STAFF RECOMMENDATION
1721 5th Avenue North
August 21, 2013

Application: New construction--infill
District: Salemtown Neighborhood Conservation Zoning Overlay
Council District: 19
Map and Parcel Number: 08108046200
Applicant: Gail Wales
Project Lead: Melissa Baldock, melissa.baldock@nashville.gov

<p>Description of Project: Application is to construct a duplex on a vacant lot.</p> <p>Recommendation Summary: Staff recommends approval of the duplex infill with the following conditions:</p> <ol style="list-style-type: none"> 1. Staff review and approve the materials for the porch columns, porch floor, foundation, and side bay accent materials 2. Staff review and approve all window and door selections prior to purchase and installation. 3. Staff review and approve the roof shingle and metal color. 4. Double and triple window openings have a four to six inch (4"-6") mullion in between them. 5. The HVAC unit be placed at the rear, or on a side façade beyond the midpoint of the house. <p>With these conditions, staff finds that the project meets Section III of the <i>Salemtown Neighborhood Conservation Zoning Overlay Handbook & Design Guidelines</i>.</p>	<p>Attachments A: Photographs B: Si

1721 5TH AVE N. HOMES
 NASHVILLE, TN 37207
 ELEVATIONS
 HISTORIC SUBMITTAL
 9-30-13
 1341
A4

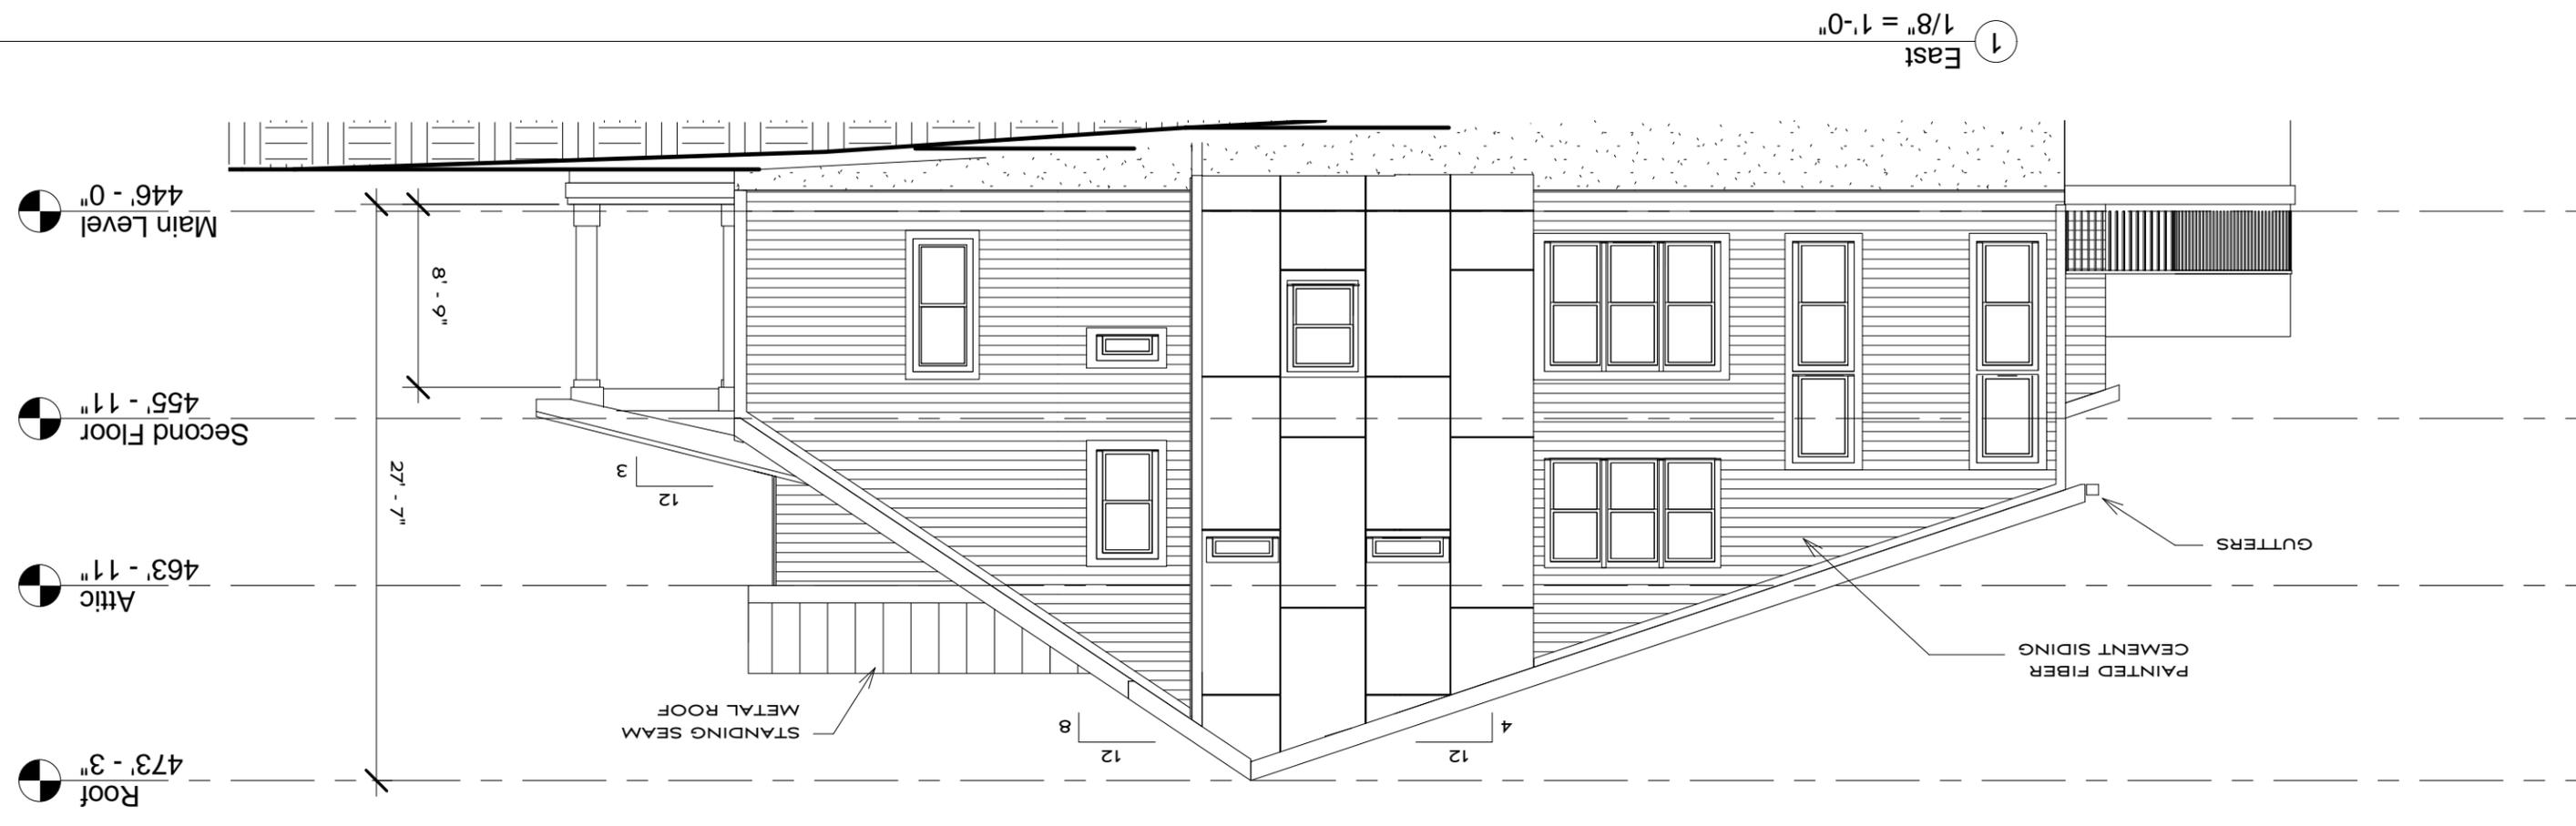
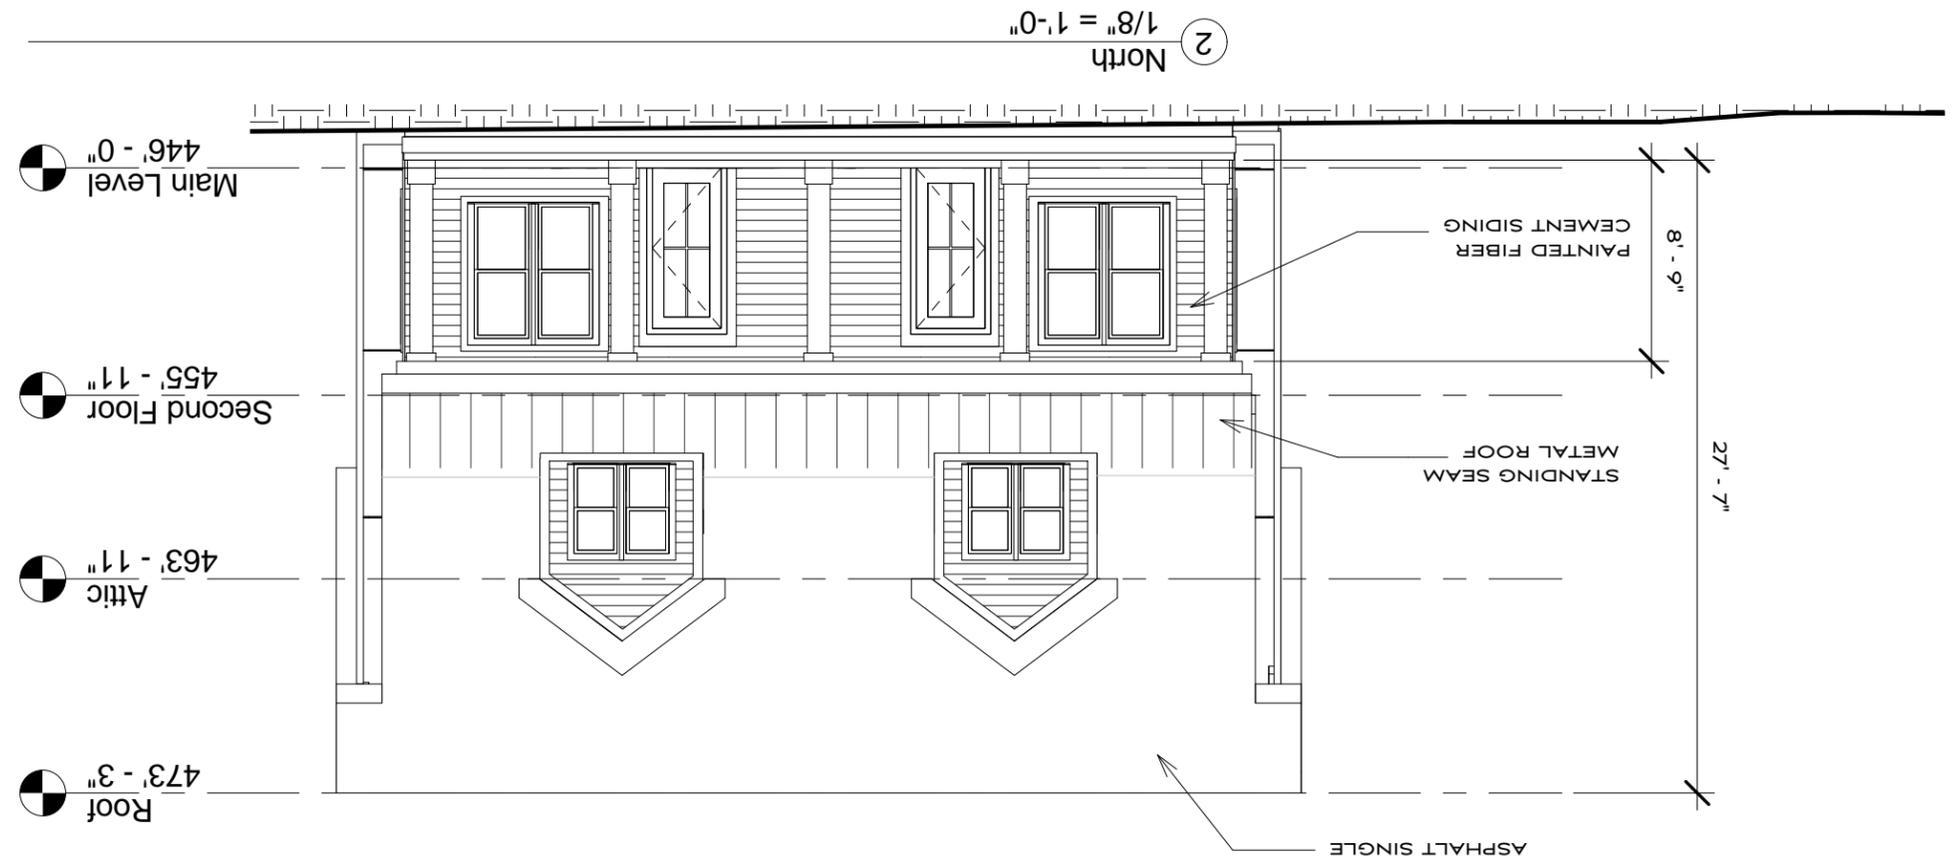
The house will have an eave height of approximately eleven feet (11'), and a ridge height of approximately thirty feet (30') from grade when seen from the front. By comparison, the houses in the immediate vicinity have heights that range from sixteen feet to thirty-two feet (32'). Staff finds that the duplex's height and scale meet Sections III.A. & III.B. of the *Salemtown Neighborhood Conservation Zoning Overlay: Handbook & Design Guidelines*.

Roof. The house's primary roof form will be a side gable. The front slope of the gable will have an 8/12 pitch, while the back portion will have a 4/12 pitch. The front dormers will be gabled with an 8/12 slope. The dormers are set back from the front wall of the house by two feet (2'), which is appropriate. The front porch roof will be shed with a slope of 3/12. Staff finds that the duplex's roof form meets Section III.E. of the *Salemtown Neighborhood Conservation Zoning Overlay: Handbook & Design Guidelines*.

1721 5TH AVE N. HOMES
 NASHVILLE, TN 37207
 ELEVATIONS
 HISTORIC SUBMITTAL
 9-30-13
 1341
A5

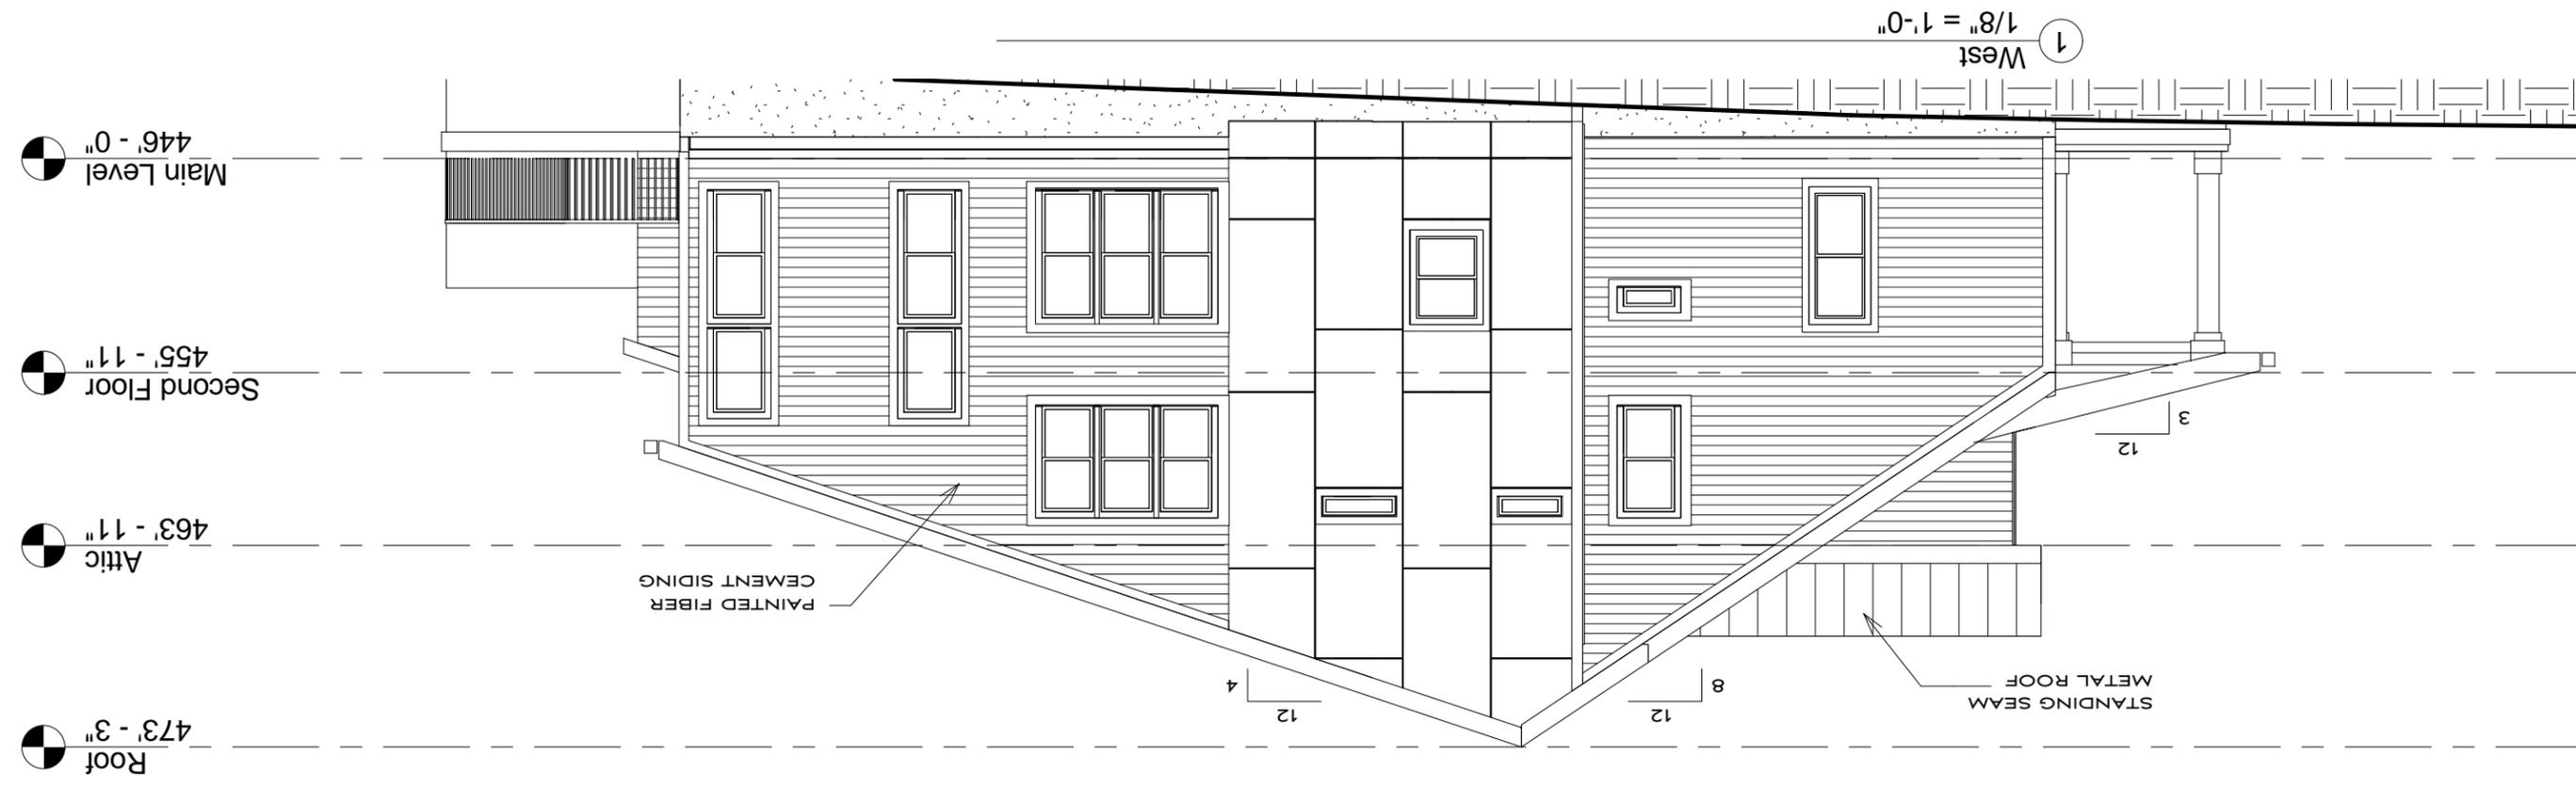
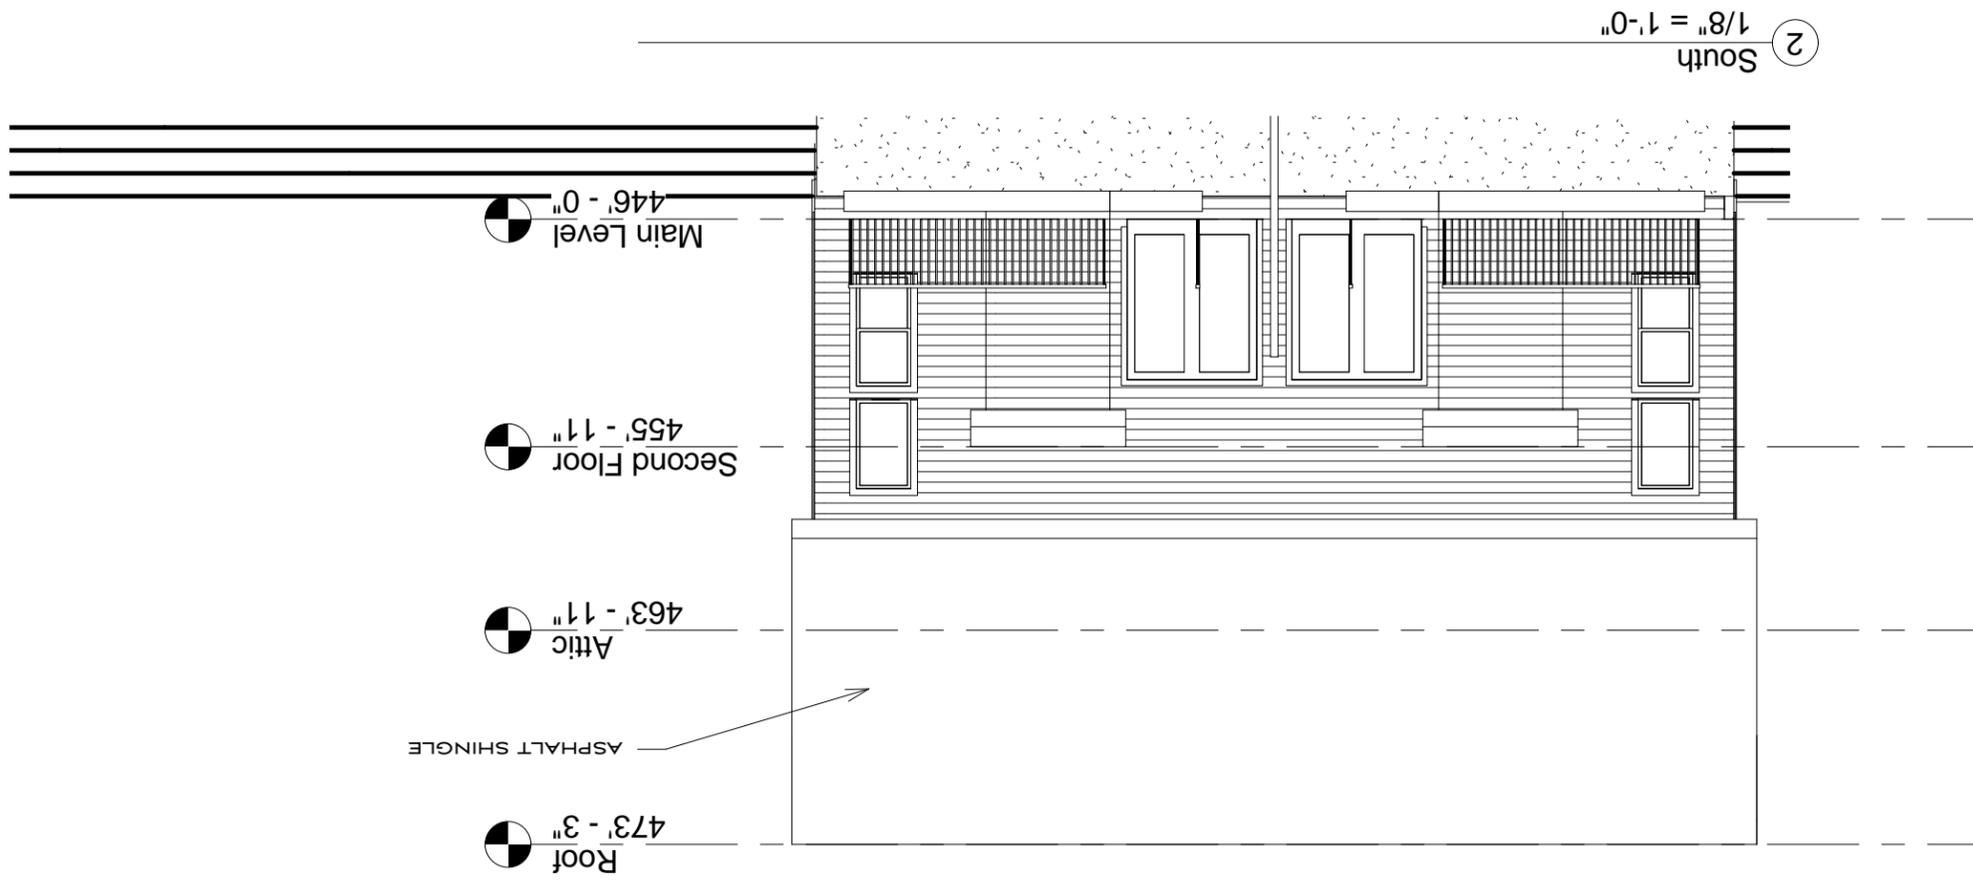
Materials. The primary cladding for the structure will be fiber cement siding with a five inch (5") reveal. The main roof will be asphalt shingle, while the porch roof will be standing seam metal. Staff asks to approve the shingle and the metal color. The trim will be wood or cement fiberboard. On each of the side facades, starting where the house becomes wider, the full-height bays will be clad-in-board and batten. The board-and-batten material was not specified, and staff asks to review it. The materials for the foundation, the porch columns, and porch floor, were not specified. Staff asks to approve these materials prior to purchase and installation. Likewise, the materials for the windows and doors were not specified, and staff asks to approve all window and door specifications. With the above-mentioned staff approval of materials, staff finds that the duplex's materials meet Section III.D. of the *Salemtown Neighborhood Conservation Zoning Overlay: Handbook & Design Guidelines*.

Proportion and Rhythm of Openings. The primary windows on the infill are twice as tall as they are wide, thereby meeting the historic proportions for window openings. Staff asks that a condition of approval be that all double and triple window openings have a four to six inch (4"-6") mullion in between them. There are no large expanses of wall space without a window and door opening, which meets the typical rhythm of openings for historic structures. Staff finds that the duplex's proportion and rhythm of openings meet Section III.G. of the *Salemtown Neighborhood Conservation Zoning Overlay: Handbook & Design Guidelines*.
